**20/02/2023 - Z-Upgrade 2.05a PATCH NOTE**

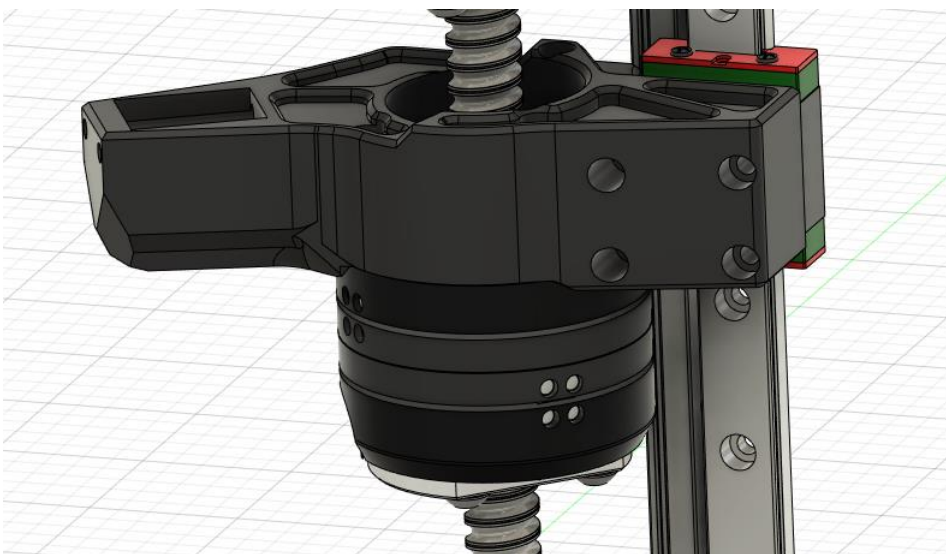
1-[FIX] Holes resize from 5mm to 6.4mm for Ruthex heat inserts :

2-[FIX] Rear NEMA17 holes refitted to adapt a m3x35 instead of a short lenght m3x30 :

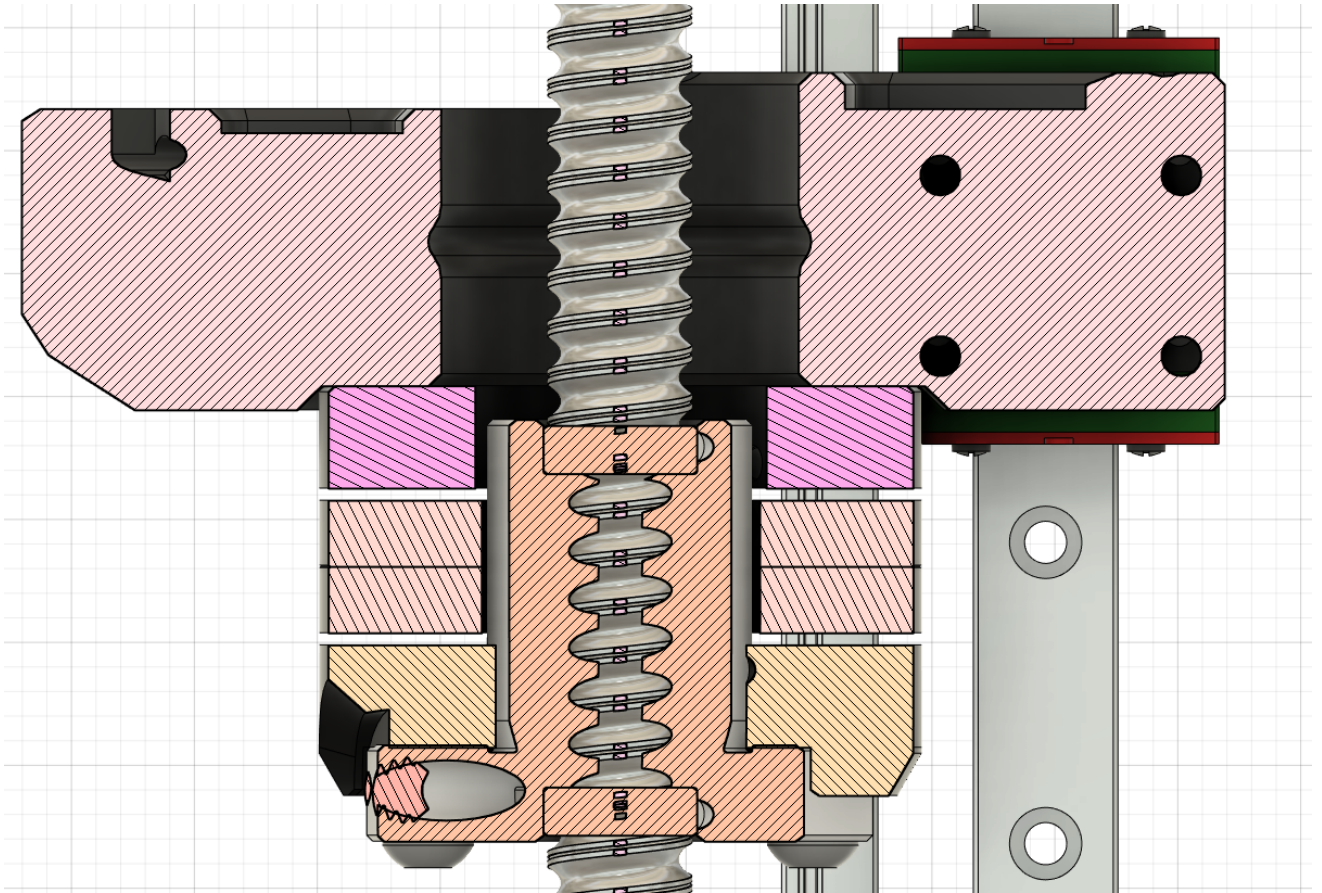
3- [ADD] New front arms designed to adapt the 3.1 rails layout, opening compatibility to RR Stock 2.0 Enclosure

4- [ADD] Those new arms featured a shorter thickness to gain 5mm more over Z distances, and has a different structure to be more rigid due to the less stable fonction over the 3.0 layout (IMO)
